CHANGE NOTIFICATION

January 25, 2013 PCN#: 012513

Subject: **Notification of Assembly Process change for LTM8025 and LTM8047**

LTM8025- Current and New DESIGN

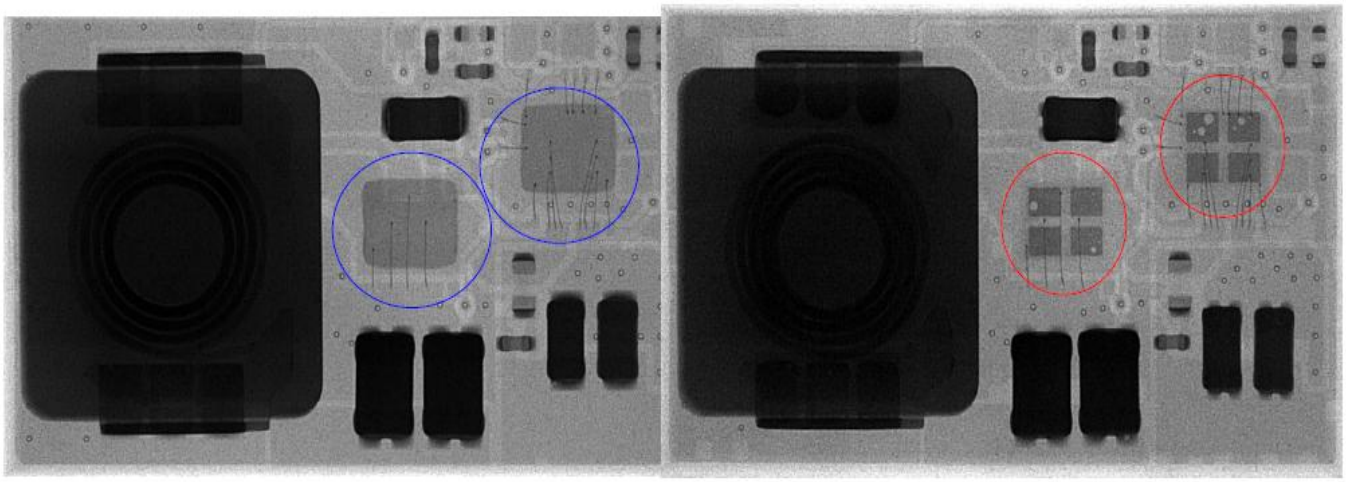
Please be advised that Linear Technology Corporation has made a minor change to the internal package construction to facilitate the use of one attach material for both die and components. The die attach material is changed from epoxy to solder, which is already used for attaching components in the same µModule device package. In order to use the solder die attach, the die attach paddle (DAP) has been modified by splitting the DAP into multiple pads for dice D1, Q1 and U1. Linear has been shipping several µModule devices using solder for die attach and component attach.
